Subject: Comments on CalWater FEIR attached

Subject: Comments on 800 Carlisle Well and Tank FEIR attached

RE: Formal Objection to the Proposed Final EIR for 800 Carlisle Way Well & Water Tank Project – Inaccuracies and Omissions regarding Operational Noise and Heritage Tree Removal

5/27/2025 Presentation to Planning commission

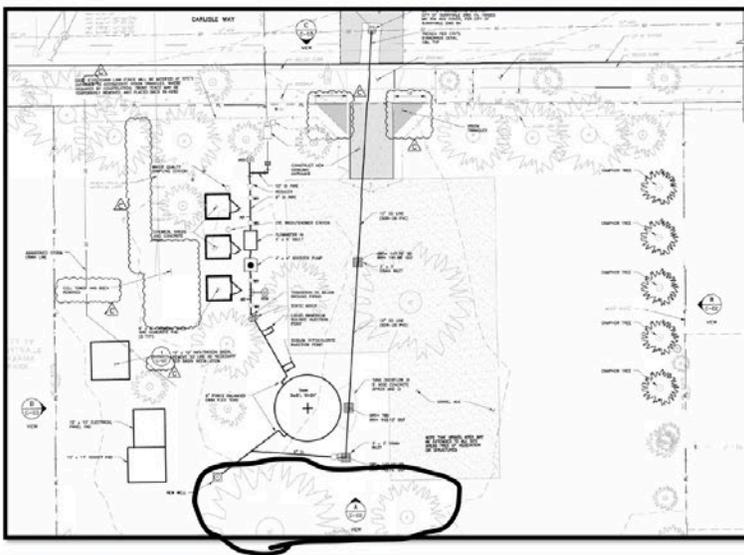
Presentation to Planning Commission 5/27/25, comment says 8 trees to be removed (up from the prior 4) **but no**

disclosure that the new tree removals are all heritage trees, critical to blocking views of the new tank. Also note that heritage tree 439 (circled below) now on the to be removed list remains on some of the site drawings. Tree 439 also is crucial to block tank views from the south and southwest.

This tree is also a nesting site for Coopers Hawks
